VEHICLE RECALL

**G-05507
August 2005**

SUBJECT: SAFETY RECALL (U.S., EXPORT)

Child Seat Latch Attachment on CE, FE, and RE School Bus models with Child Restraint Anchorage Systems Option (Property Codes 0048SYH, SYJ, TAN, TGY, TGZ, TJV, TMU, TMV, TMW, TMX, TNB, TPY, TXW) built between 05-12-2003 and 03-02-2005

Figure 1. Latch anchor brackets cut-off and belts installed

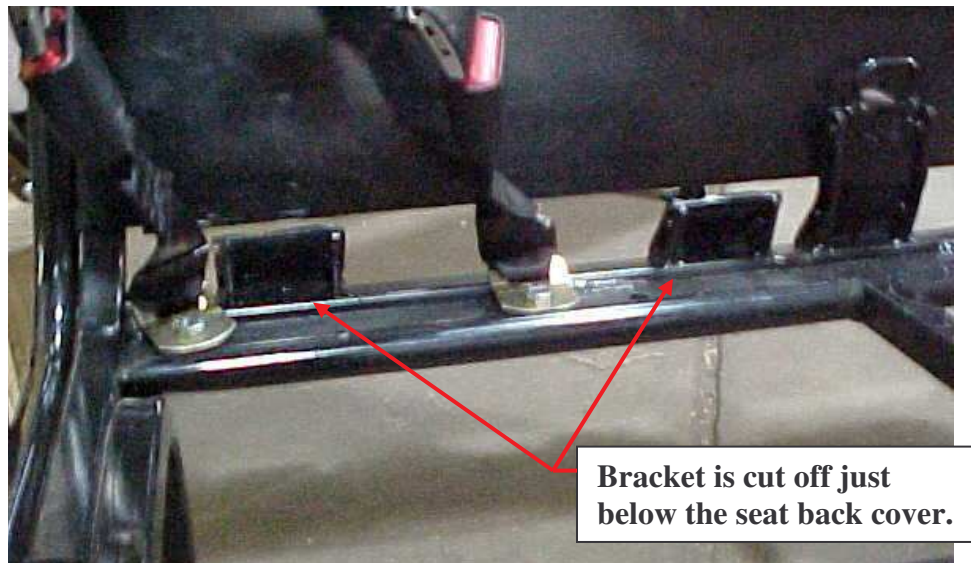
The diameter of the latch attachment bars may be so large as to make it difficult to use with future car seat attachments. Not attaching the child seat properly may result in personal injury or death.

In addition, some of the latch attachments may be located too far forward of the seat back. This placement of the brackets may result in personal injury to a passenger not seated in a child seat.

Remove latch attachments from seats and replace with a special belt system. This procedure does not require the removal of the seat assembly. Refer to Figure 1.

2. Cut the brackets off just below the seat back cover. Refer to Figure 1 below.
 - The bracket makes a bend in this area and has a minimum amount of material to cut through. It can be cut off closer to the seat frame if desired.

- There are two (2) brackets on 26" and 30" seats.
 - There are four (4) brackets on 39" seats.
3. Grind all cut edges smooth.
4. Paint.

- 1. On seats without existing lap belts** (Texas, North Carolina and Laidlaw only):
 - a. After removal of the latch system, add one set of belts and hardware provided in **Kit # 8900150R91** (at each position that the latch system was removed) using the holes provided in the bar that are approximately eight inches apart.

- b. You may need to place a large diameter flat washer between the belt mounting bracket and the plate in the seat to get a flat mounting.
 - c. Torque the fasteners to **21-27 LbF-Ft (28.5–36.6 Nm)**.
